Office Action Summary	Application No. 10/813,863	Applicant(s) VAQUERO, EDWARD	
	Examiner AMY T. LANG	Art Unit 3731

DETAILED ACTION

5. **Claims 1, 3, 4, 6-13, and 22-25** are rejected under 35 U.S.C. 102(e) as being indefinite by Swick (US 2003/0233078 A1).

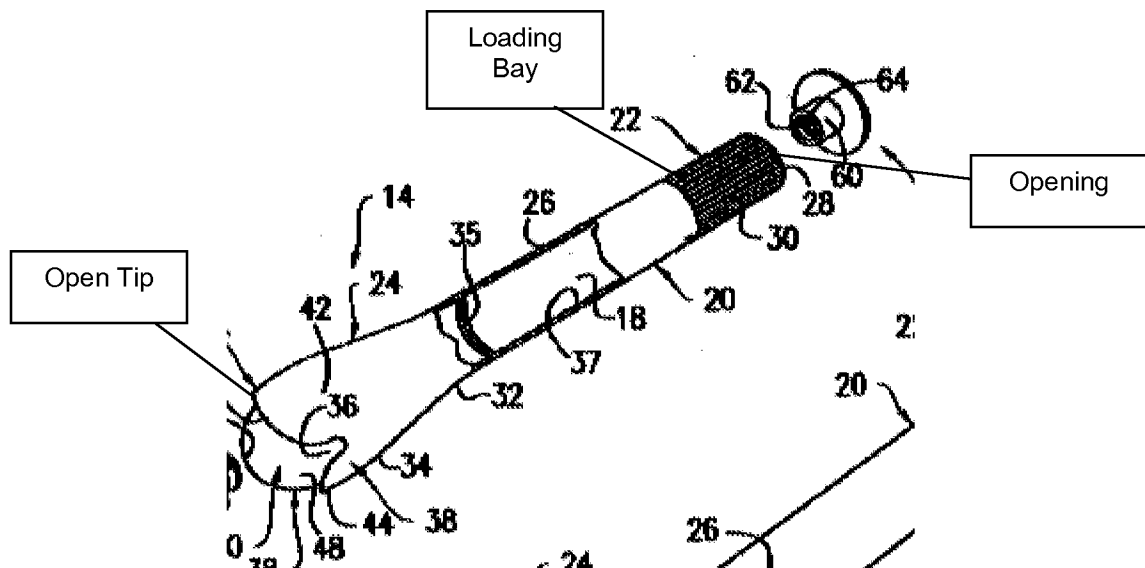
With regard to **claims 1 and 23**, Swick discloses a device comprising an injector body (14) having internal lumen (18) ([0018]; [0019]). As shown in Figure 1, the lumen is sized to permit transport of an IOL therethrough. Additionally, the lumen is configured such that it comprises a proximal opening, a loading bay just distal of this opening, and a distal open tip (shown below). Since the opening opens into the loading bay, the opening is configured and arranged to permit placement of an IOL into a loading bay. Furthermore, the inner diameter of the lumen at a location immediately adjacent and distal to the loading bay is less than an inner diameter of the lumen at the open tip ([0019]). It is also the Examiner's position that plunger (16) overlaps the claimed compressor since it is connected to the injector body at a location proximate the

opening (Figure 2) and is configured and arranged to compress an IOL (Figure 6; [0024]; [0025]).

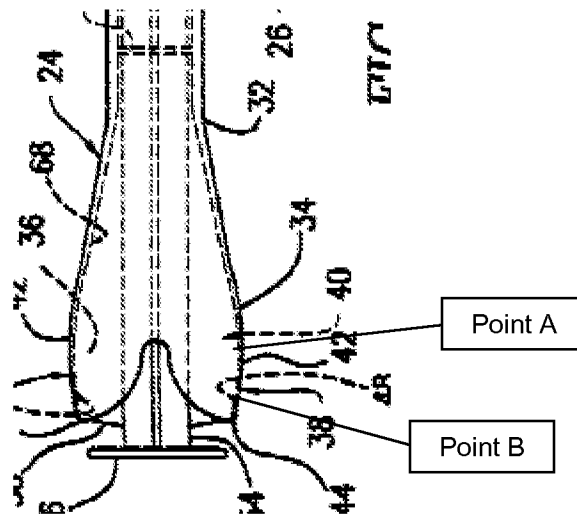
With regard to **claim 6**, as shown in Figure 7, the outer diameter of the injector body has is substantially constant from point A to point B, as shown below. Point A is adjacent the location where the IOL is initially placed since it is close to this location (noting that since the two points are on the same device they are close in location). Point B is the open distal tip.

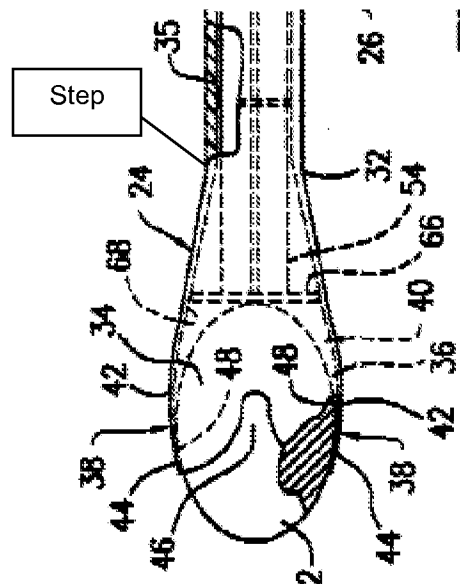
With regard to **claims 9, 11, and 13**, it is also the Examiner's position that the lumen also includes at least one step in increase, as shown below. Although the entire lumen diameter increases gradually, it still comprises at least one interval increase.
